**PLANNED UNIT DEVELOPMENT  
STAFF REPORT****Date: March 1, 2012****DEVELOPMENT NAME**

EGM Properties, LLC

1617 Industrial Park Circle and 3748 Industrial Park Drive  
(North side of Industrial Park Drive, 525'± West of Varner  
Drive and extending West to the East side of Industrial  
Park Circle, 175'± North of Industrial Park Drive)

Planned Unit Development Approval to amend a  
previously approved Planned Unit Development to allow  
multiple buildings on a single business site, and shared  
access and parking between two building sites.

# SITE PLAN

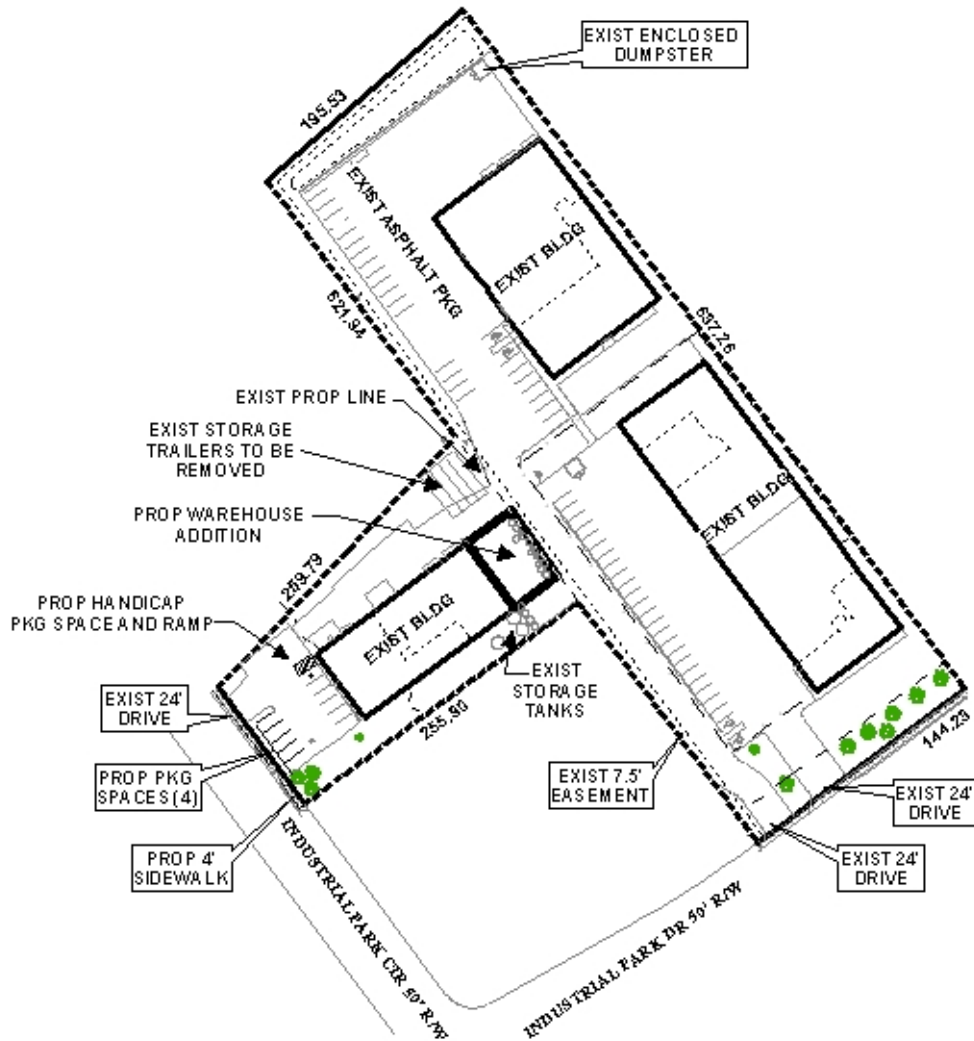
The proposed warehouse addition appears to extend nearly to the common property line: a zero-foot or a minimum 5-foot setback is allowed in an I-1 district, thus the proposed expansion must either be zero or a minimum of 5-feet from the common property line.

Aerial photos from 2010 indicate that access between the two building sites was added between 2006 and 2010 (with additional possibly unpermitted paving), thus the application at hand would legitimize the access, but move it to a different location. The proposed point of access between the two sites may put a corner of the expanded warehouse at risk of damage by trucks and other large vehicles making a turn.

The aerial photos also indicate that various storage containers and tanks are kept on the site and that the large storage containers appear to be placed on landscape areas. No outside storage or containers are indicated on the submitted site plan. The site plan should be revised to depict outside storage areas, and any storage containers that are essentially permanently kept on the site.

It appears that the storm water detention area on the existing PUD site is being used for trailer storage: storage of any items in the storm water detention area may reduce the storm water compliance of the facility. Revision of the site plan to depict a barrier between the parking area and the storm water facility may be necessary to prevent parking in the storm water facility.

Information provided regarding tree and landscaping compliance indicates that the site will meet all requirements of the Zoning Ordinance, however, aerials indicate that the trees depicted on "Parcel A," as well as some of the landscape areas, do not reflect the as-built condition.

As for parking, it appears that the 61 proposed parking spaces will exceed the minimum required. It appears that some of the parking bumpers depicted on the site plan have been removed, and that the fence that separated the "Parcel A" parking and driveway to the rear building has been removed: the site plan should be revised to reflect the actual parking and fence conditions of the site.

It should also be pointed out that the depicted handicap parking may not comply with the requirements of the Americans with Disabilities Act, in that at least one space must be van-accessible, and must have an access aisle of a width complying with van-accessible requirements. The site plan should be revised to depict compliance with any applicable requirements of the Americans with Disabilities Act.

The 25-foot setback is not shown along the Industrial Park Circle frontage, but should be depicted on the revised PUD site plan.

The site plan depicts a new sidewalk along Industrial Park Circle. A sidewalk should be required as part of the proposed building expansion.

*A revised site plan was submitted, addressing all issues identified by staff. The size of the proposed warehouse expansion has increased from 2,400 square feet to 2,480 square feet, to bring the warehouse to the common lot line.*

*The “Parcel B” site will not have adequate parking on-site, thus additional parking spaces are being added to “Parcel A” to satisfy parking requirements. It appears, however, that combined the two sites will be short of parking. Parcel B needs 15 spaces, while Parcel A needs 44 spaces, for a total of 59 spaces: a combined total of 57 spaces are being provided. The site plan should be revised to add 2 more spaces, in a manner that will not compromise circulation, Fire access or increase the amount of pavement.*

- 1) Revision of the site plan to depict a total of 59 parking spaces;
- 2) Placement of a note on the site plan stating that site and parking lighting will comply with Sections 64-4.A.2. and 64-6.A.3.c. of the Zoning Ordinance;
- 3) Compliance with revised Engineering comments (1. Any proposed development will need to be in conformance with the Storm Water Management and Flood Control Ordinance. 2. The site will need to provide drainage calculations that take into account the amount of accumulated impervious area added to the site since 1984. 3. A complete set of construction plans for the site work (including drainage, utilities, grading, storm water
